現本就所有政府的提問作出下列回應

Application No. Y/SK-TMT/7

Comments from Government Departments (as at 25.11.2022)

Plan Extracted from "仁義路\_SurveyPlan  
wih digital format from Land  
Surveror.dwg" submitted by the applicant

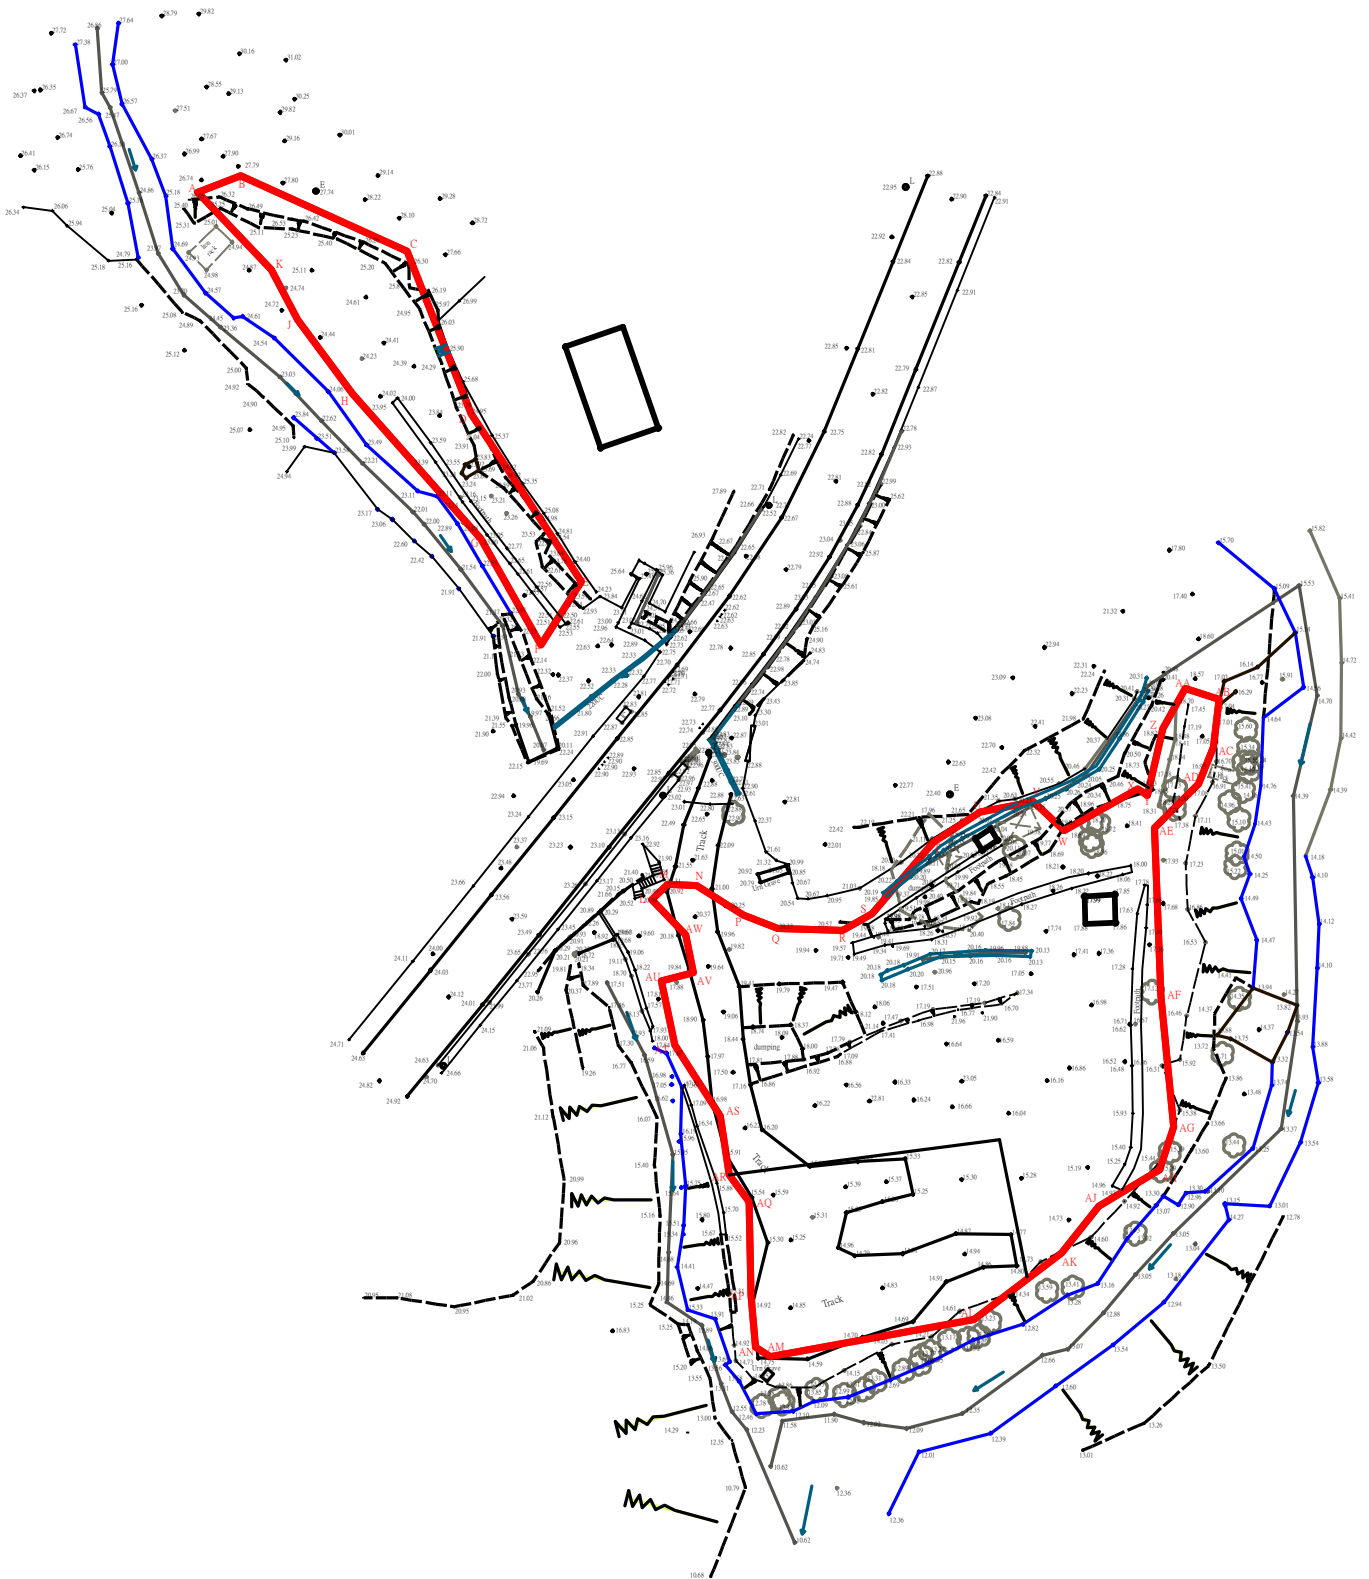
(ii) as stated in the planning statement, the application site is of about 1,996m<sup>2</sup>. This Office cannot verify the site area at the moment. The applicant should make sure that the site data quoted in the submission is correct. The applicant should make sure that the site data quoted in the submission is correct;

- (i) 我是以一份由“梁守晇註冊土地測量師 Leung Shou Chun Land Surveying Consultants Ltd 於 2008 年為我作實地測度及制圖的, 而給予我的是一份 Autocad 格式的 Digital Format 在圖中,更以紅線及 AA 点到 Z 点, 需知目前政府各有關測量及圖則等, 大家都一至使用相同的 Autocad 來呈交及制度, 而我也以相同的電腦呈式來運自, 也多次來運算後, 原來是 1998.62 平方米,但我也自我減小為 1776 平方米來計算, 而業界也接受 5% 的誤差, 當然我也只少了些許來以 1776 計算, 本是合理的,日後批准換地時,會要求土地測量師給予更精準的面積, 而地政處因以 acre 來算, 故是有很大的差距.
- (ii) 因面積在我看來是正確的, 我也為此把原來的 AutoCad Digital Format 提供給地政處或相關部門來參考.
- (iii) 有關該申請地有僭建物一事, 我已與地政處專責執行組協商, 已把 80% 的僭建物拆卸, 預計三十天左右就可以把一切全拆卸.
- (iv) 目前該土地的登記業主是 Key Fortune Development Limited 但因申請人已佔用該土地超過 12 年, 為此申請人也與業主協商好, 會給予一個他滿意的賠償額, 故在多方面的申請中, 業主也願意給予支持及以授權書等來給予證明, 日後在換地時, 我會正式向法庭申請逆權侵佔後把身份更清晰來確認.
- (v) 這個在上已有回應.
